ANSI/ASHRAE/IESNA Addenda a, b, c, g, h, i, j, k, l, m, n, p, q, s, t, u, w, y, ad, and aw to ANSI/ASHRAE/IESNA Standard 90.1-2007

2008 SUPPLEMENT

Energy Standard for Buildings Except Low-Rise Residential Buildings

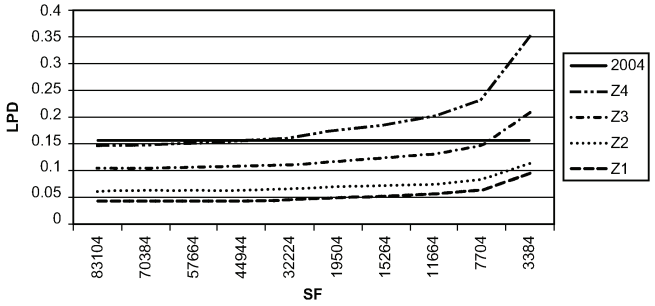
The first change in Section 9.4.5 is the deletion of the 5% additional power allowances, which is replaced by a base wattage allowance per site. The second change to this section is to define the four zones and apply appropriate requirements. The four zones are based on IESNA and other group definitions to match other requirements and guidance expected to be encountered by designers. The majority of building sites will fall into LZ3, LZ2, or LZ1, and the sites that remain in LZ4 will generally be of relatively small sizes. The added "Base Site Allowance" for each zone takes into account that most sites are not rectangular or match the iso-diagram of typical light luminaires.

The associated energy change from this proposal comes from the lower illuminance requirements for primarily zones 1–3, where the majority of buildings are constructed. Numerous point-by-point lighting calculations were performed for parking lots, walkways, stairways, pedestrian tunnels, entries (with and without canopies), sales canopies, service stations, and auto dealerships for the four zones. In the initial calculations for the parking lots, there was a noticeable difficulty in achieving the recommended light level when the space was 20,000 ft^2 and lower, without any additional power allowance (this was especially true in zone 4). Six odd shaped parking lots were modeled for all four lighting zones to verify that the requirement would cover varying design needs. This modeling was used to determine appropriate base site allowances. Because of the base site allowance, the actual LPDs are on a sliding scale, as shown below.

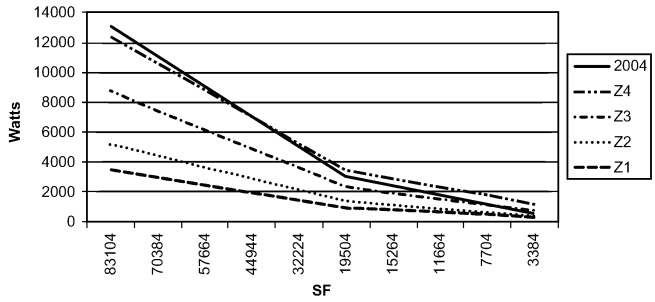
The energy savings from this zone approach is shown in the chart below, with total energy used in each lighting zone for the various square footages. The solid line is the current 2004 standard.
